# Consideration of Comments

## Project 2010-17 Definition of BES – Phase 2

8. Do you have any questions or comments on the text and system diagrams for the hierarchical application of the definition? If so, please be as specific as possible and cite figure numbers where appropriate

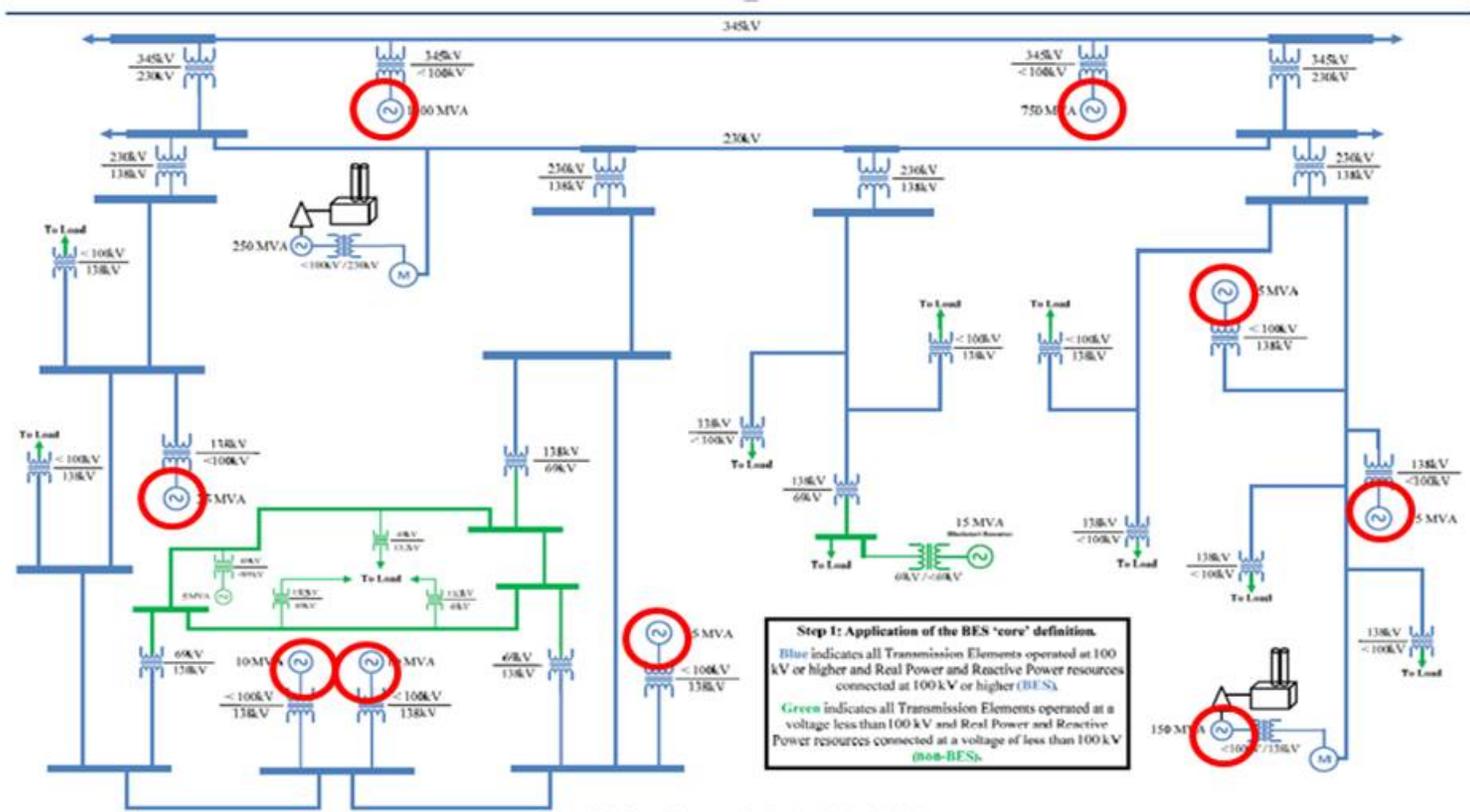
Organization	Yes or No	Question 8 Comment
PacifiCorp	Yes	<p>Items circled in red are not part of the core definition and should be green, they will be added to the BES, or left excluded from the BES as part of the inclusions (see Figures S1-5, and S1-6</p>  <p><b>Step 1: Application of the BES 'core' definition.</b>  <b>Blue</b> indicates all Transmission Elements operated at 100 kV or higher and Real Power and Reactive Power resources connected at 100 kV or higher (BES).  <b>Green</b> indicates all Transmission Elements operated at a voltage less than 100 kV and Real Power and Reactive Power resources connected at a voltage of less than 100 kV (non-BES).</p> <p>Figure S1-3: System Diagram – Application of 'Core' Definition</p> <p>BES Definition Guidance Document – DRAFT for Comment – January, 2014</p>
MRO NERC Standards Review Forum	Yes	<p>o Appreciate additional examples in the full application system diagram but suggest working in some more key elements and key configurations into this helpful system diagram (e.g. a plant with aggregate rating greater than 75</p>

Organization	Yes or No	Question 8 Comment
		<p>MVA, a two unit plant less than 75 MVA with one unit greater than 20 MVA, a dispersed power producing resource, a BES reactive resource, a non-BES reactive resource, a less than 50 kV loop, a N.O. switch, a N.C. switch, etc.)</p> <ul style="list-style-type: none"> <li>o Some of the text boxes refer to specific application steps (e.g. Step 2a, Step 3b.2ii, etc.). Modify the hierarchical application text and/or the Figure text boxes to more clearly refer to the specific application steps.</li> <li>o For Figure S1-2, add wording to the text box to explain that this figure is included to provide IROL information that will be used later for the Exclusion E3 examples, otherwise remove this figure.</li> <li>o For Figure S1-7, is nice for recap purposes, but could be put to better use by illustrating the application of I4 and I5 - a dispersed power producing resource, a static BES reactive resource, and a static non-BES reactive resource.</li> <li>o For Figure S1-9b - This figure should be relabeled as S1-10a and retitled, 'Application of E1a &amp; E1b (Part 1)', since it is not E3 (embedded radial systems). If this figure is really illustrating E1a and E1b, then why are the single point of connection only noted at the "thick line" locations? There are 8 other single points of connection from "thin line" locations on the right side of the diagram that were not circled. If there is a valid rationale for not recognizing the "thin line" connection locations, then there should be text in the E1 section and the introduction to the full application system diagram to explain the differentiation.</li> <li>o Figure S1-10 should probably be called S1-10b, 'Application of E1 (Part 2)' and Figure S1-10a should probably be called S1-10c, "Application of E1 (Part 3)".</li> </ul>

Ameren	Yes	<p>We request a diagram similar to Figure S1 for evaluation, but instead of the 5 MVA generator connected to the 69 kV network (see lower left), we would like to see two 50 MVA generators connected to this 69 kV network. The generators have traditionally been operated as peaking units, but could be called on in emergency conditions to deliver power to the BES (flow out of the 69 kV network) as needed. Other than the decision to push a starting button during certain times of the year, what separates the “is not part of the BES” from the “could be part of the BES”? We see nothing in the exclusion process that allows engineering judgment to be applied.</p> <p>We also request a diagram similar to S1-9a but with flows (red arrows) from the 138 kV to 69 kV on two of the transformers and one flow from the 69 kV to the 138 kV on the other transformer.</p>

Georgia Transmission Corp	Yes	<p>Figure S1-4 identifies Step 2a for xfmrs. Technically, xfmr(s) connected to generation at &lt;100kV should be circled and turned green during this step also; Some may turn back to blue with I2, but this step is for I1.</p> <p>Figure S1-6 through S1-11: the xfmr connecting the blackstart resource &lt;100kV and the line connecting the resource to the xfmr should be colored black because I3 only addresses the blackstart resource.</p> <p>Figure S1-9b: There are obvious E1a radials serving only load not circled and turned green on the right side of this drawing. Either turn green, or you could insert the note from figure S1-10 regarding embedded radial systems to be consistent.</p>

**Summary Consideration:** The SDT reviewed all comments and appreciates the time and effort that everyone put into reviewing this document. The SDT made the following changes due to comments:

- Revised Figures S1-9, S1-9a, and 1-9b to shade the parts of the diagram that are being analyzed
- Removed the term ‘Transmission’ from the text box for the green, or non-BES Elements, in Figure S1-3

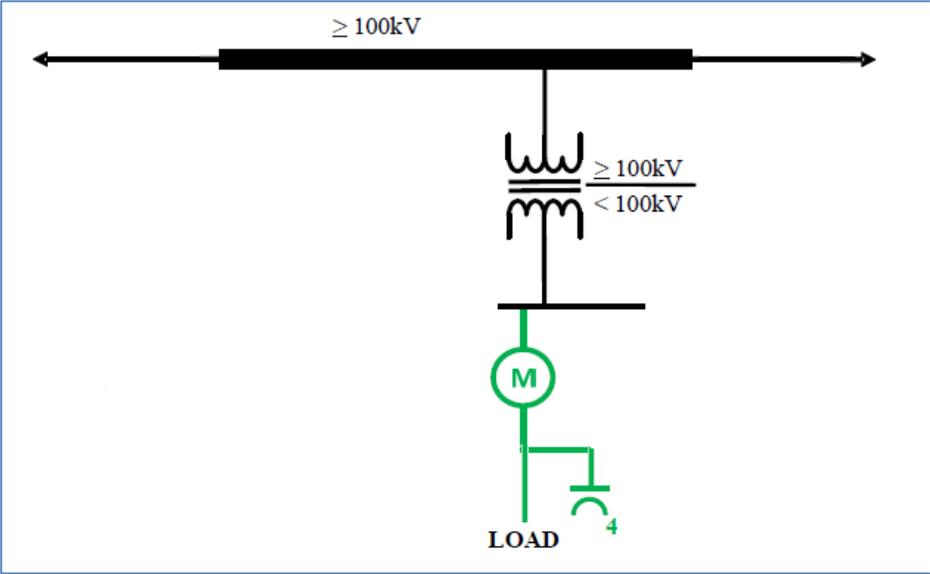
Dominion	Since the application of the definition is based on the hierarchical application of determining the BES, the exclusions and inclusions, Dominion suggests moving the current section IV. Hierarchical Application of the Definition to Section 1 following the Introduction.

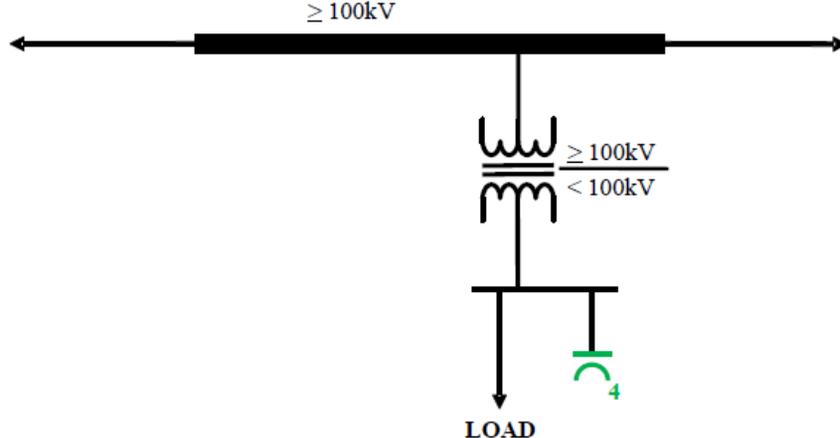
<p>Northeast Power Coordinating Council</p>	<p>Since the application of the definition is based on the hierarchical application of determining which elements are in or not in the BES (by exclusions or inclusions), we suggest moving the current section IV. Hierarchical Application of the Definition to Section 1 following the Introduction. Recommend that the BES definition be stated in the summary portion of the document to provide an overview before diving into the various pieces (inclusions and exclusions) in the application guide. At a minimum a cross reference to the final definition needs to be provided in this document.</p> <p>There are application inconsistencies in the treatment of "radial lines". In similar situations radial lines are sometimes included, and other times excluded. In Figure E1-7, the radial line connecting a non-BES generator is included; in Figure E1.11, the radial line connecting load facilities are included. However, in Figure E1-19, the radial lines from the normally closed breaker to the load facilities are excluded; in Figure S1-11 for the portion of the system feeding the blackstart resource the radial lines connected to load facilities are also excluded. The lines mentioned in those examples should all be excluded.</p> <p>Suggest the following wording revisions and clarifications to the Exclusion E4 write-up: To Section III.4 BES Exclusion E4 beginning on page 79:E4. Reactive Power devices installed for the sole benefit of a retail customer(s).Exclusion E4 is dependent on the intended function</p>

Organization	Question 9 Comment
	<p>of the Reactive Resource. Delete “therefore, figures were not developed for Exclusion E4 due to the simplicity of the language in the exclusion.” Add the following wording: Where the purpose of the Reactive Resource is to serve retail customers and not the BES, then the Reactive Resource may be excluded under Exclusion E4. Reactive Resources used to prevent retail customer service interruptions, e.g., from switching operations or fault clearing on Radial Systems and Local Networks, may be Excluded under E4. The Reactive Resource must not be dispatchable by a Reliability Coordinator (RC), Transmission Operator (TOP) or primarily impact the BES. The drafting team has identified the following configurations that represent example uses of Reactive Resources for the sole benefit of one or more retail customers. (Diagrams are available upon request).</p> <p>E4-1: Behind the Customer Meter A Reactive Resource installed at a single customer site behind the meter is excluded because it is for the sole benefit of that retail customer. Figure E4-1: Behind the Customer Meter</p> <p>E4-2: At a Distribution Area Station A Distribution Provider (DP) may install, own and/or operate a Reactive Resource at a Distribution Area Station to serve a retail customer or a group of retail customers, e.g., an industrial park. This device is excluded by the Core Definition that states: Bulk Electric System (BES): ... Real Power and Reactive Power resources connected at 100 kV or higher. This does not include facilities used in the local distribution of electric energy. Figure E4-2: At a Distribution Area Station This Reactive Resource is excluded because it is connected below 100kV, is part of a distribution facility, and is for the sole benefit of retail customers.</p> <p>E4-3: Connected to an Excluded Radial System A Transmission Owner (TO) may install, own and/or operate a Reactive Resource for the benefit of retail customers that is connected to a Radial System excluded from the BES under Exclusion E1. Figure E4-3: Connected to an Excluded Radial System This Reactive Resource is excluded because it is for the sole benefit of retail customers, is not dispatchable by the Reliability Coordinator (RC) or Transmission Operator (TOP) and therefore does not impact the BES, and is connected to an excluded Radial System.</p> <p>E4-4: Connected to an Excluded Local Network A Transmission Owner (TO) may install, own and/or operate a Reactive Resource connected to a Local Network excluded from the BES under Exclusion E3 for the benefit of retail customers connected to that excluded Local Network. Figure E4-4: Connected to an Excluded Local Network This Reactive Resource is</p>

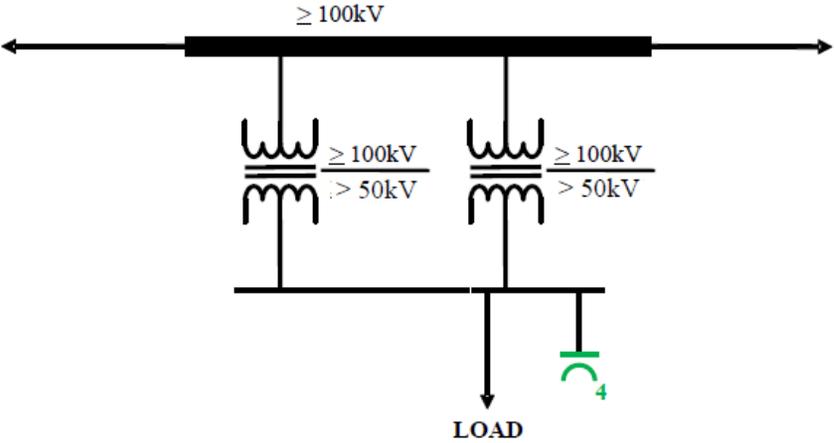
Organization	Question 9 Comment
	excluded because it is for the sole benefit of retail customers, is not dispatchable by the Reliability Coordinator (RC) or Transmission Operator (TOP) and therefore does not impact the BES, and is connected to an excluded Local Network.
Associated Electric Cooperative, Inc. - JRO00088	Thanks to the SDT for producing this, but too bad we could not have it during the voting process. (See Second part of response to Question 5.)  I3 does not specify "through the high-side of the generator step-up transformer" for Blackstart Resources, and so that transformer should technically be drawn as non-BES.
FirstEnergy	The actual BES definition as approved by FERC should be the first section of the BES Definition Reference Document.
PPL NERC Registered Affiliates	The BES Definition Reference document depicts transmission system possibilities in detail but is weak as regards to showing the internal arrangements of generation plants (e.g., feeders, station service transformers, startup transformers, and emergency gensets). Much more work remains to be done in this respect, and should be performed in conjunction with the NAGF and other trade groups representing GOs.
